Access Compliance Report

Public Rights-of-Way

(Curb Ramps)

Intersection ID: N/A	Main Street: BALTUSROL_LN	Cross Street: N/A	Location: W
ADA ID: 7BBEAC65B1DC	Ramp Type: Perp	Initial Pass/Fail: Fail	Overall Compliance: No
		Severity Score: 12.5	
Codes/Mitigation Info/Possible Solution		Field Measurements/Component Compliance

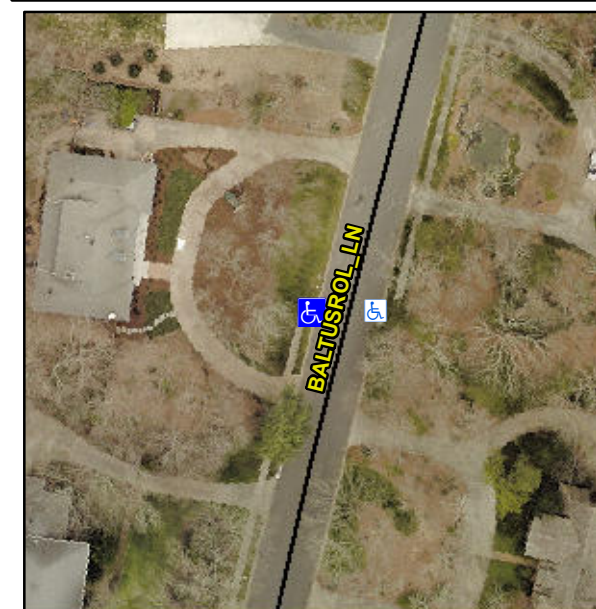
Not Found, R304.5.3

Compliance	Description	Data	Compliance	Description	Data
N/A	Ramp Length (in)	40.0	Yes	Ramp Slope (%)	7.1
Yes	Ramp Width (in)	48.0	No	Ramp XSlope (%)	6.4
N/A	Flare Type LT	N/A	N/A	Flare Type RT	N/A
N/A	Flare Slope LT (%)	N/A	N/A	Flare Slope RT (%)	N/A
N/A	Flare Traversable LT?	N/A	N/A	Flare Traversable RT?	N/A
N/A	Landing Length (in)	N/A	N/A	DWS Provided?	N/A
N/A	Landing Width (in)	N/A	N/A	DWS Contrast?	N/A
N/A	Landing Slope (%)	N/A	N/A	DWS Length (in)	N/A
N/A	Landing X Slope (%)	N/A	N/A	DWS Full Width?	N/A
N/A	Landing Curb? (Y/N)	N/A	N/A	DWS Offset (in)	N/A
N/A	Shared Landing?	N/A			
N/A	Gutter Ponding?	N/A	N/A	Gutter Slope (%)	N/A
N/A	Gutter Lip Ht (in)	N/A	N/A	Gutter X Slope (%)	N/A
N/A	Painted X Walk1?	No	N/A	Painted X Walk2?	N/A
	X Walk 1 Direction	To E		X Walk 2 Direction	N/A
N/A	X Walk 1 Width (in)	N/A	N/A	X Walk 2 Width (in)	N/A
	X Walk 1 Slope (%)	5.1		X Walk 2 Slope (%)	N/A
	X Walk 1 X Slope (%)	5.3		X Walk 2 X Slope (%)	N/A

Remove & Replace Entire Ramp.
